File MS-1995-042

Project Name: Fisher Re-plat

**North Mall Subdivision
a Resubdivision of Lot 2
FISHER SUBDIVISION**

RESPONSE TO REVIEW COMMENTS

NORTHMALL SUBDIVISION

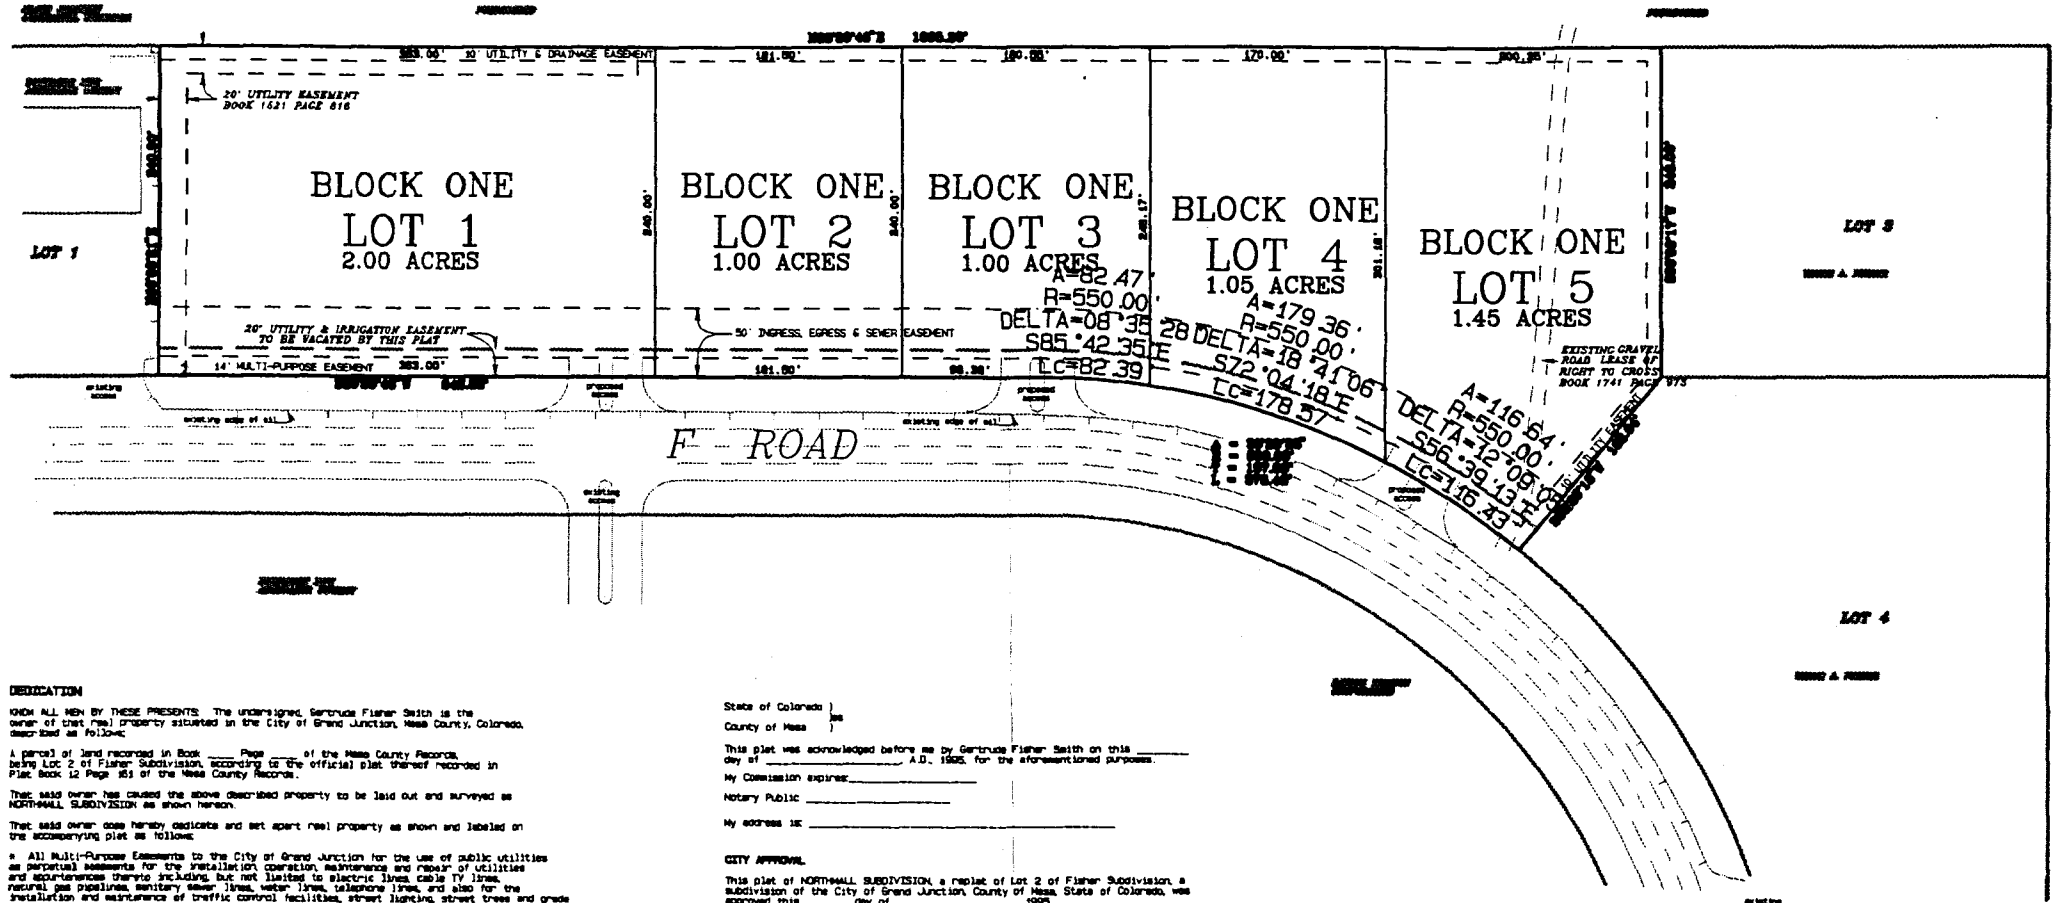
1. The plat must be revised to show all technical requirements (see attached).
2. Four sets of final construction drawings for all public improvements, including utilities and drainage improvements,

1. A note must be added to the plat stating that at the time of site plan review, access, circulation, common access circulation and parking arrangements must be reviewed and approved by City staff.
2. Original mylar plat needs owner's signature and the Surveyor's Statement signed and sealed.
3. City signatures needed on the plat.
4. The following copies of the fully signed plat must be submitted: 2 full size mylar copies (in addition to the original) and 1 11"x17" reduced mylar copy of the plat.
5. A computer disk with the final plat information must be submitted.
6. The fully executed Development Improvements Agreement/Guarantee, etc. as agreed upon by the City Attorney.
